RZ19-0012: Request approval for a rezoning from R-1, RP-1, RP-4, and CTY A Districts to R-1 District, and preliminary plat for **Prairie Canyon** on 73.19± acres; located in the vicinity of the southwest corner of the intersection of College Boulevard and K-7 Highway.

RZ19-0014: Request approval for a rezoning from R-1, RP-4, and CTY A Districts to R-2 District and preliminary site development plan for **Prairie Canyon** on 18.20± acres; located in the vicinity of the southwest corner of the intersection of College Boulevard and K-7 Highway.

STAFF REPORT

Applicatio	on:	RZ19-0012: Rezoning from R-1, RP-1, RP-4, and CTY A to R-1 District and preliminary plat for Prairie Canyon						
Location:		Southwest of the intersection of College Boulevard and K-7						
Owner:		Trust o	f Sandra G. M	litchell	; West Olathe, Ll	LC		
Applicant	t:	Frank I	Dean, Prime L	and D	evelopment Corr	ipany		
Engineer	:	David I	Rinne, PS; Scł	hlagel	& Associates, P.	A.		
Staff Con	tact:	Sean F	Pendley, Senio	or Plan	ner			
Site Area	: <u>7:</u>	3.19± acres		Prop	osed Use:	Single-Fam	ily Residential	
Lots:	<u>1</u> 4	<u>42</u>		Plat:		<u>Unplatted</u>		
Density: <u>1.</u>		94 units per acre		Prop	osed Zoning:

PRELIMINARY PLAT PRAIRIE CANYON

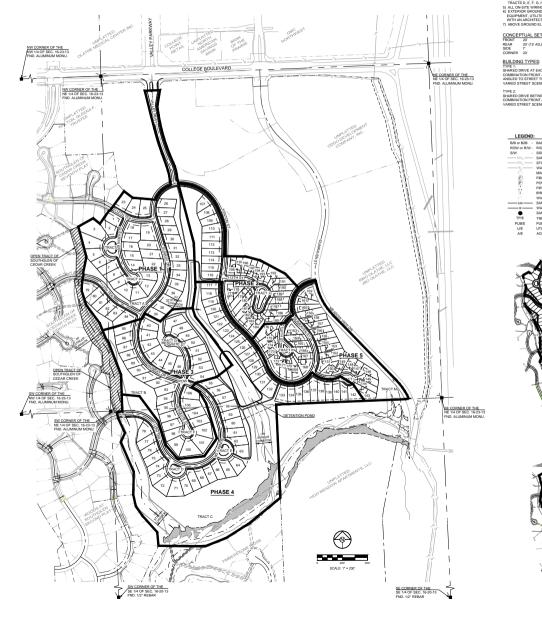
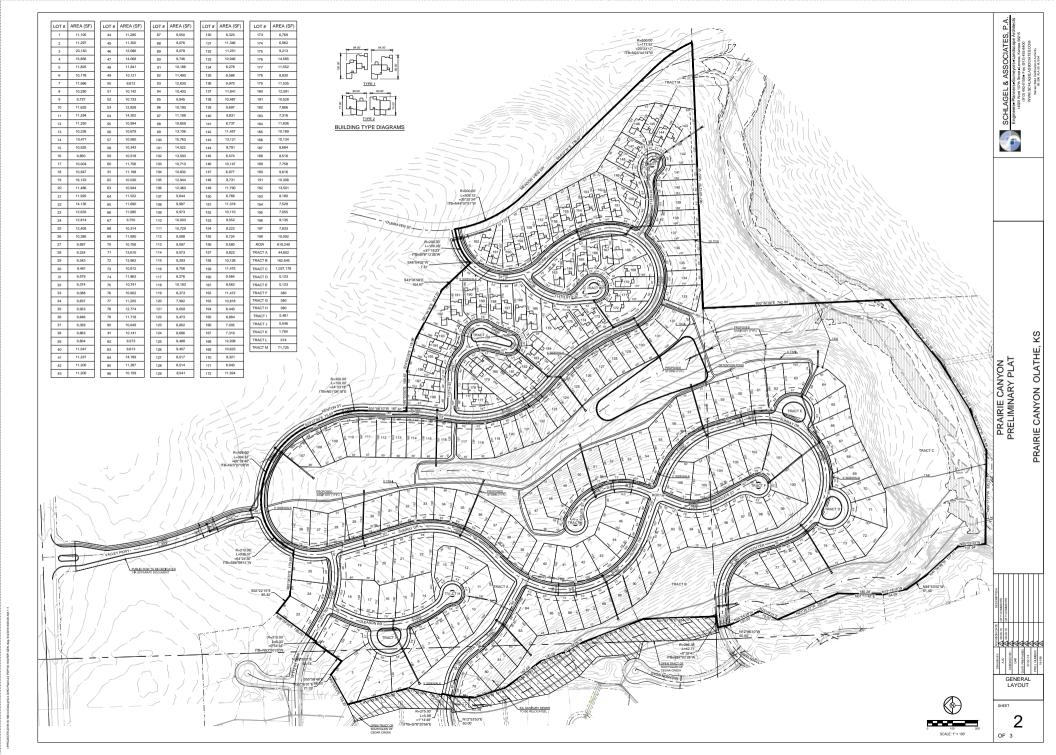
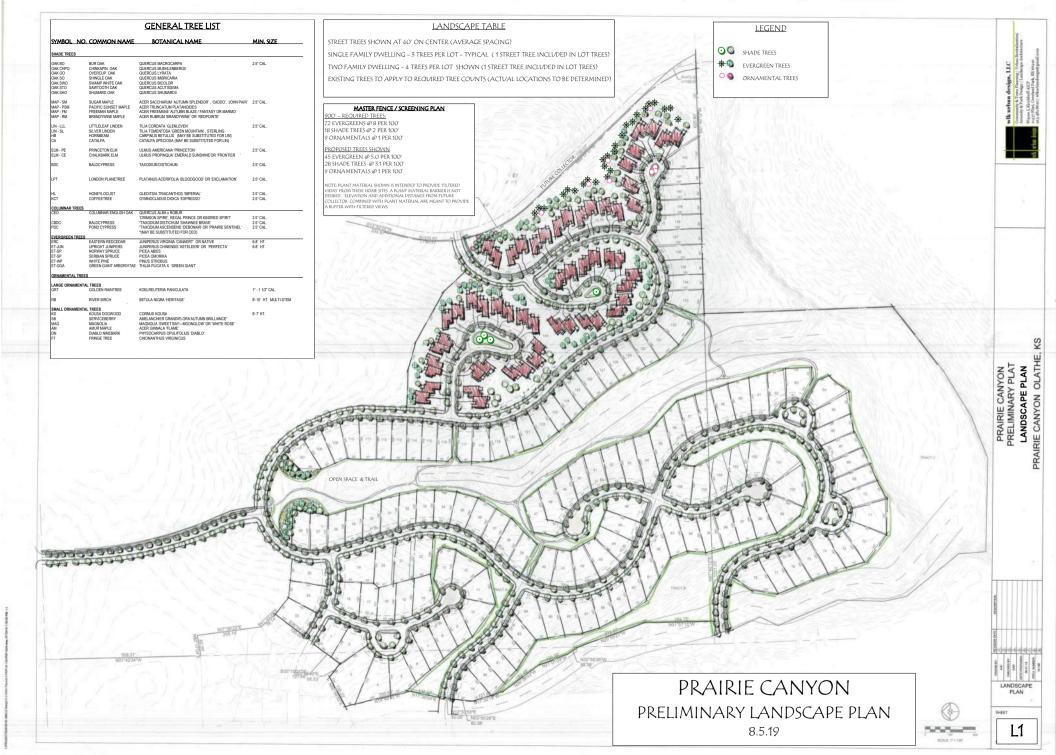
All lots within the proposed subdivision will have access from new local streets. The road network for the proposed subdivision will have four (4) connections from existing roads: College Boulevard to the north, and 112th Terrace, 113th Terrace and 115th Terrace to the west. The street connections to the existing neighborhood in Southglen of Cedar Creek provide a well connected street network and improve opportunities for access and traffic circulation per Unified Development Ordinance requirements. According to (UDO) 18.30.220, "Local street patterns may discourage through traffic but should also include interconnecting streets with alternative routes throughout the neighborhood to diffuse automobile traffic and shorten walking distances". The streets in the Southglen neighborhood were constructed with the intent that they would one day be extended, which is why they are currently street stubs rather than cul-de-sacs.

The preliminary plat identifies private trails within Tract C. The City of Olathe also has plans for a future public trail in the stream corridor along the south plat boundary. The final plat will include a Public Recreation Easement (PR/E) to allow construction of the future public trail. The exact location of the trail and specific easements will be determined at the time of construction for the trail.

The applicant has provided a preliminary landscape plan depicting the location of street trees along the residential streets. Street trees are required with an average spacing of 40 linear feet, with at least one tree per lot in residential districts. Single family homes require a minimum of three (3) trees on each lot.

A landscape buffer is not required adjacent to the existing residential properties, however, staff recommends that the required interior lot trees for some of the proposed single family lots be located in the rear yard to provide landscaping in the rear yards where existing trees will be removed or there is no existing vegetation.

The applicant is requesting a waiver from Unified Development Ordinance (UDO) requirements to reduce the front yard setback in the R-1 District from 30 feet to 20 feet. The primary reason for the waiver request is to provide additional tree preservation areas in the rear yards and open space tracts with steep grades and along existing residential properties. The applicant's waiver request letter is included within this packet.

- 3. A minimum of two (2) interior lot trees will be provided in the rear yards of Lots 1-5, 79 and 80.
 - 4. Final plats shall include Tree Preservation Easements (TP/E) in Tract C as identified on the preliminary plat.

5. As required by the *UDO*, all exterior mechanical equipment or utility cabinets located within front yards or corner lots shall be screened from public view with landscaping.

PRELIMINARY PLAT PRAIRIE CANYON

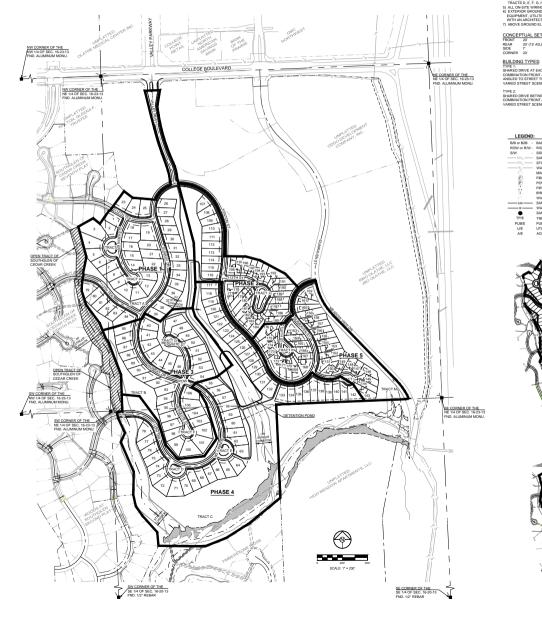
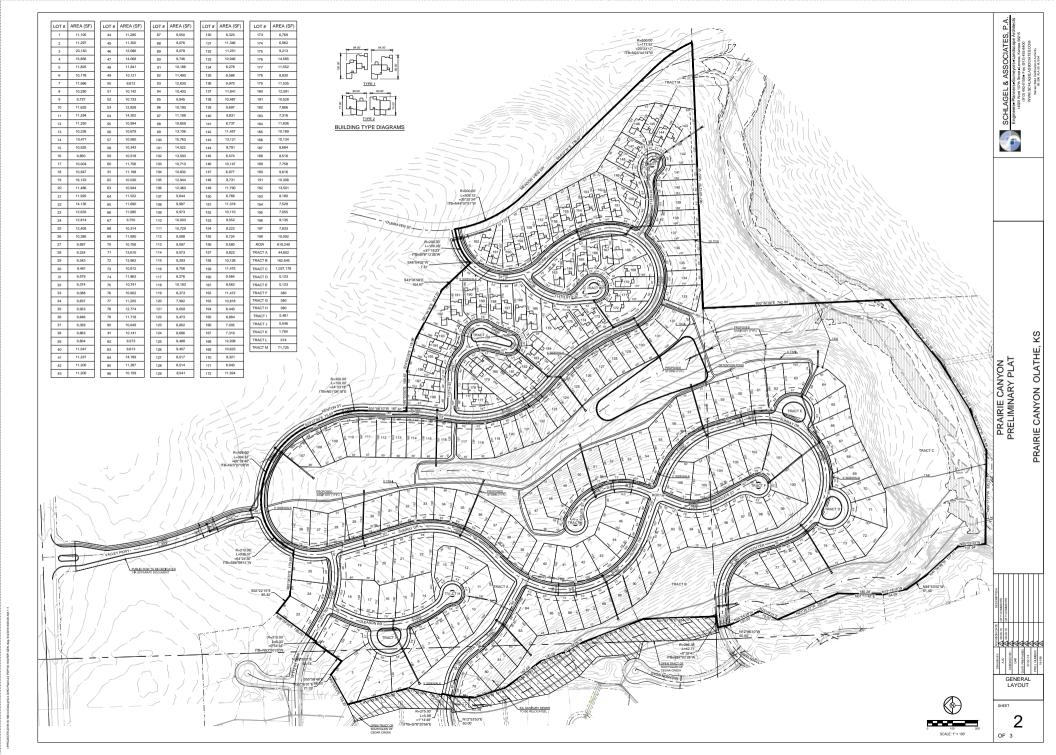
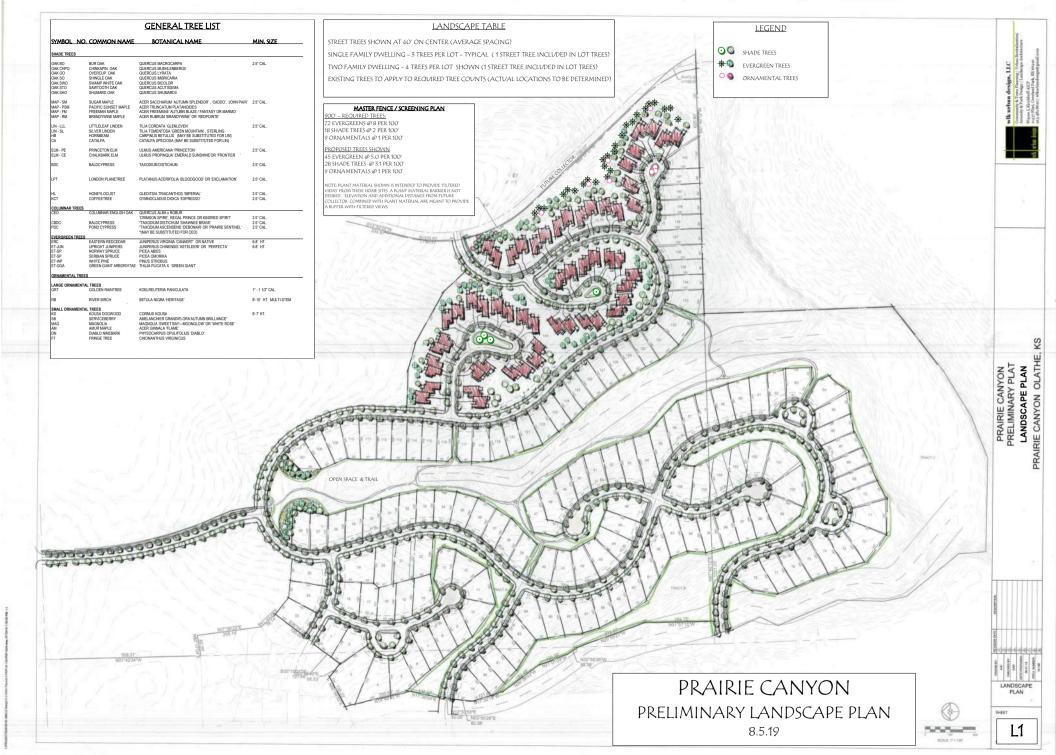
The preliminary plat show sidewalks on one side of the streets which is typical for single family residential development. Sidewalks are required on both sides of streets in R-2 developments per *UDO* requirements. Since some of the lots have rear yards facing local streets, sidewalks should only be required on both sides of the cul-de-sacs where there are front yards on both sides of the streets.

The City of Olathe also has plans for a future public trail in the stream corridor along the south plat boundary. The final plat will include a Public Recreation Easement (PR/E) to allow construction of the future public trail. The exact location of the trail and specific easements will be determined at the time of construction for the trail.

The applicant has provided a preliminary landscape plan depicting the location of street trees along Tallgrass Drive. A 15-foot landscape buffer is provided along the northern property line, adjacent to the right-of-way for W. 124th Street, as required for residential properties adjacent to collector street right-of-way. This landscape buffer will be provided in common tracts so as to not interfere with individual lots.

A landscape buffer is not required adjacent to the existing residential properties, however, staff recommends that the required interior lot trees for the proposed single family lots be located in the rear yard to provide some landscaping in the rear where there are some existing trees and overgrown native vegetation that will be removed during grading and the installation of utilities.

- 2. The single family homes on lots less than 7,200 square feet and two-family homes are subject to building design standards per UDO requirements.
- C. The following stipulations apply to the preliminary site development plan:

- 1. A final site development plan and final plats will be approved prior to issuance of building permits.
 - 2. The final plat(s) will include a note stating that single family homes on lots less than 7,200 square feet and two-family homes are subject to building design standards per UDO requirements.

- 3. The final plat must include a Limits of No Access on the rear yards of lots 163-177 and lots 179-190.
- 4. Sidewalks are required on both sides of streets with front yards, including 113th Street, 114th Street and 114th Place, per *Unified Development Ordinance (UDO 18.30.180).*
- 5. The final plat with Tract M will include the following language: "A Public Recreation Easement (PR/E) will be dedicated in Tract M to allow a future public trail. The exact location of the public trail and PR/E will be determined at the time of the trail construction by the City of Olathe".
- 6. As required by the UDO, all exterior mechanical equipment or utility cabinets located within front yards or corner lots shall be screened from public view with landscaping.
